Subject : FW: Draft MHI report - Review of the Muskrat Falls and Labrador Island HVdc Link and the Isolated Island Options

Review of the Muskrat Falls and Labrador Island HVdc Link and the Isolated Island Options

Prepared for:
Hon. Jerome Kennedy, Q.C.
The Minister of the Department of Natural Resources
Government of Newfoundland and Labrador

October 26, 2012

Figure 8: Typical HVdc Transmission Guyed Tangent Structures which comprise approximately 85% of the towers in the Labrador-Island HVdc transmission line

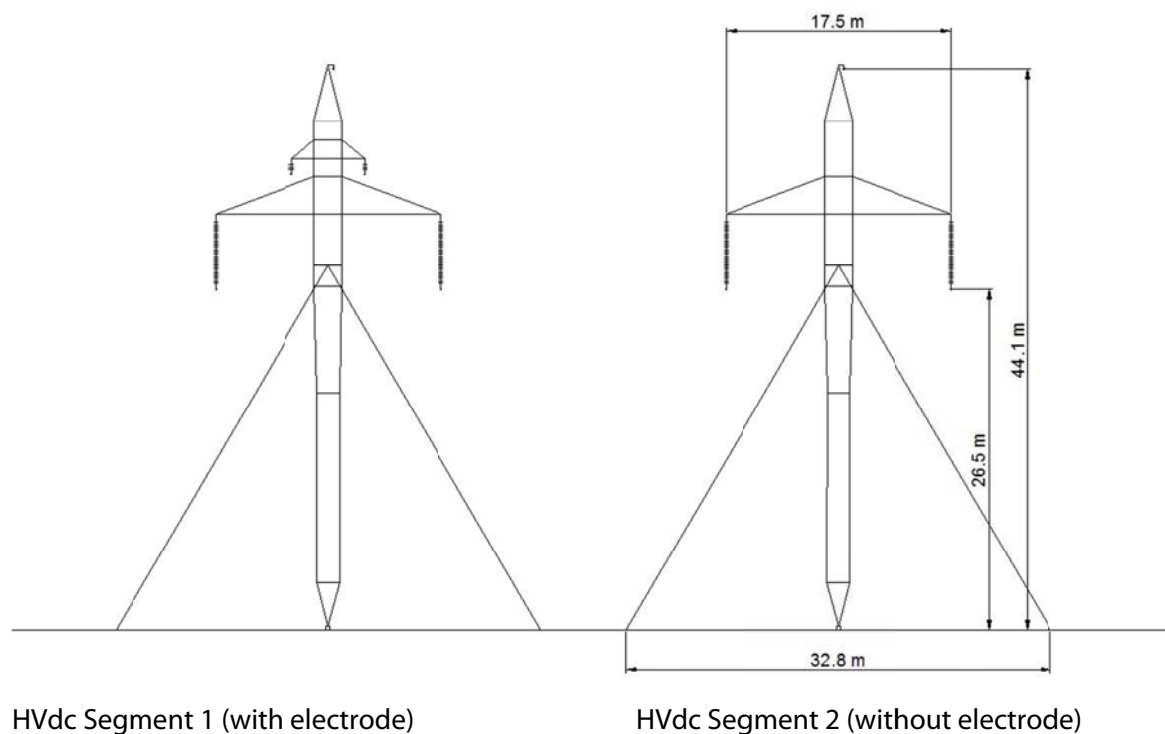
Engineering work is in progress to complete the detailed design for the HVdc line. Nalcor has defined 12 structure families, with a total of 25 structure types, required to economically construct the line. Wherever possible, an effort was made to use common structures in the various loading zones in an effort to minimize the number of unique, custom structures which mitigates design and construction cost.

Nalcor's design controlled the structure loading from the various ice-and-wind loading combinations by reducing or increasing the ruling span in the 11 weather-zone regions. Generally, as the loading increased, the design ruling span and conductor tension was

Figure 9: Climatic Ice Loads along the HVdc Transmission Line Route compared to the CSA Standard 1:500-year return period limit

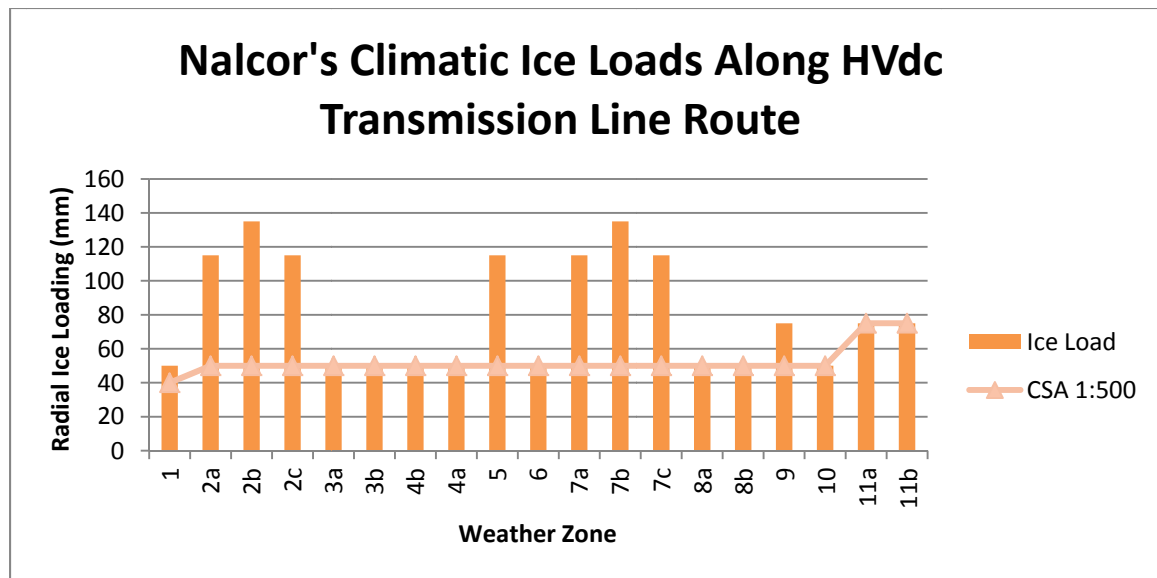
MHI finds Nalcor has completed a thorough assessment of the various climatic regions impacting the ± 350 kV HVdc line from Muskrat Falls to the Soldiers Pond transmission line route. In documents provided by Nalcor to MHI, the meteorological research determined that 11 zones along the route corridor with a number of subzones, each with a unique zone-specific climatic loading is required to reliably predict climatic loading to the transmission line. Nalcor's research studies to define the climatic loadings along the transmission line route were based on approximately 50 years of data acquired from various sources, as outlined in the document "Muskrat Falls Project – Exhibit 97, Appendix A Revision 1".

The climatic loadings for each line section were selected based on Nalcor's past research studies and statistical analysis of the climate data based upon a 50 year observation period. Extreme values based upon historical data and observations on ice accumulation and wind speed were implemented in the line regions through the Long Range Mountains and other regions in Labrador as illustrated in , which possibly increases the reliability return period to possibly 1:150 or greater in these areas.

The climatic loadings Nalcor selected for each line section are approximately equivalent to the climatic loadings calculated assuming a Canadian Standards Association (CSA) 1:500-year return period. When making direct comparisons between the two loadings it should be noted that the CSA climatic loading tables are based on generalized data sets for the Newfoundland area which contain no information on regional extreme loading experienced along much of the line route.

MHI notes that CAN/CSA C22.3 suggests a greater reliability of design to 1:150-year or 1:500-year return periods for lines of voltages greater than 230 kV which are deemed of critical importance to the electrical system. It is MHI's opinion and recommendation the ± 350 kVdc and 315 kV ac lines proposed for the Lower Churchill Project be classified in a critical importance category due to their operating voltage and role in Nalcor's long term strategic plan for its transmission system and be designed to a reliability return period greater than 1:50 years.
